SERVICE INFORMATION LETTER NO. 0046

Date: March 19, 1976

Subject: Damper Modification

Model: F-28A, F-28C, 280 & 280C

Figure 1

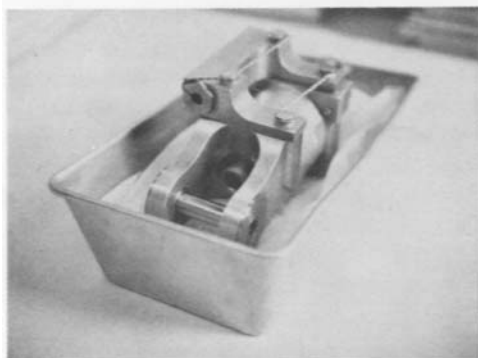
- b. Remove the safety wire from the four reservoir retaining bolts and plug. Place the damper assembly on its side, with the reservoir and retaining bolts facing up, in a clean shop pan or on a clean shop cloth (see Figure 1).

Figure 2

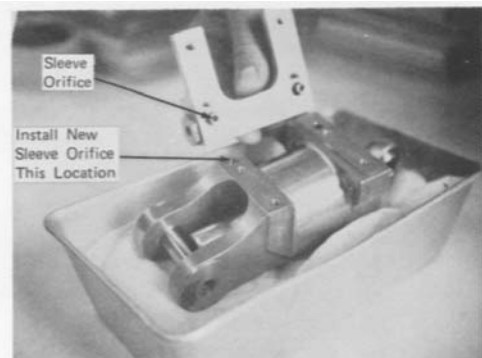
- c. Remove plug from reservoir end, remove the four reservoir retaining bolts, and lift reservoir from the damper housing. The position as described in paragraph (b) should be maintained so as not to allow air to enter the piston cavity. Oil loss from the reservoir will be replaced on assembly. It should be noted that discoloration of the silicone oil is common and should be disregarded. See Figure 2.
